Town of Berthoud Planning Commission Meeting
Town Hall
807 Mountain Avenue
Thursday, December 12, 2024, at 7:30 p.m.

5. **Public Hearing - Consider A Request For A Preliminary Plat For The Legacy Park Subdivision**

STAFF REPORT: LEGACY PARK PRELIMINARY PLAT

2024-10-21 LTWD Comments

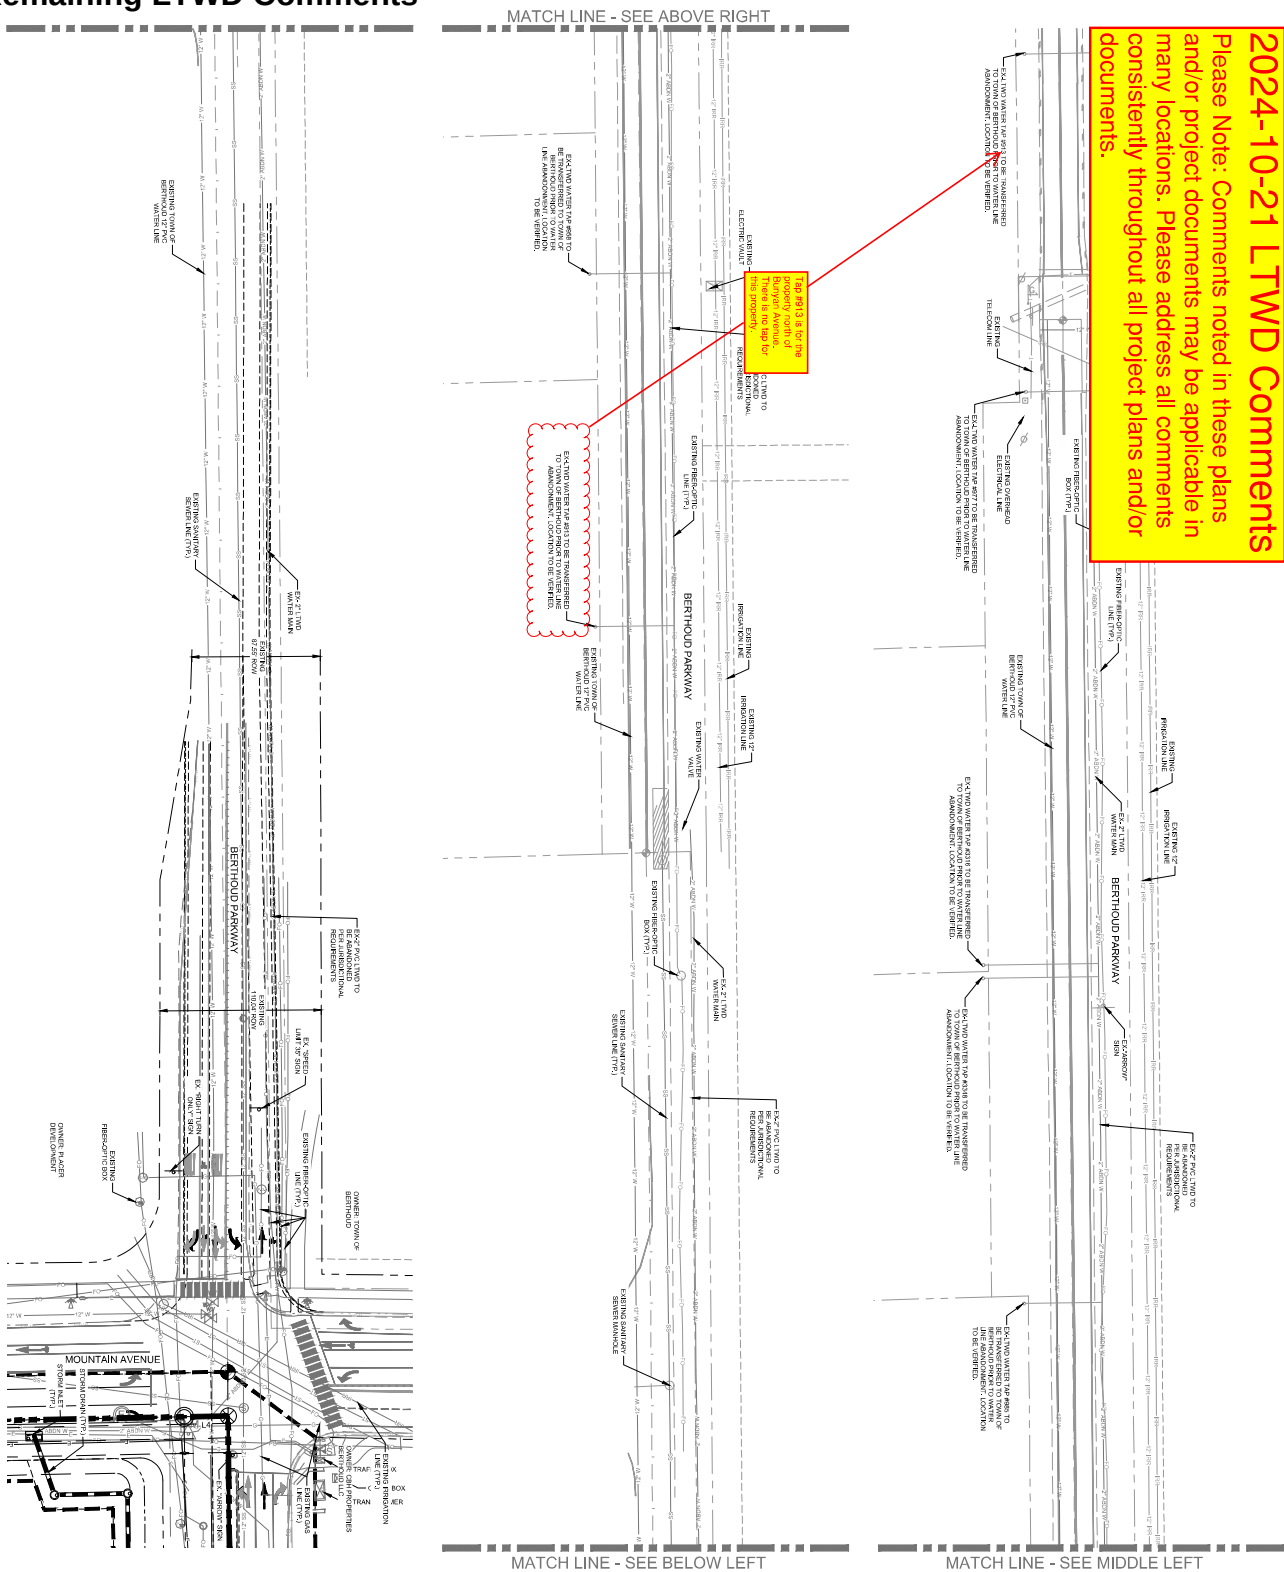
Please Note: Comments noted in these plans and/or project documents may be applicable in many locations. Please address all comments consistently throughout all project plans and/or documents.
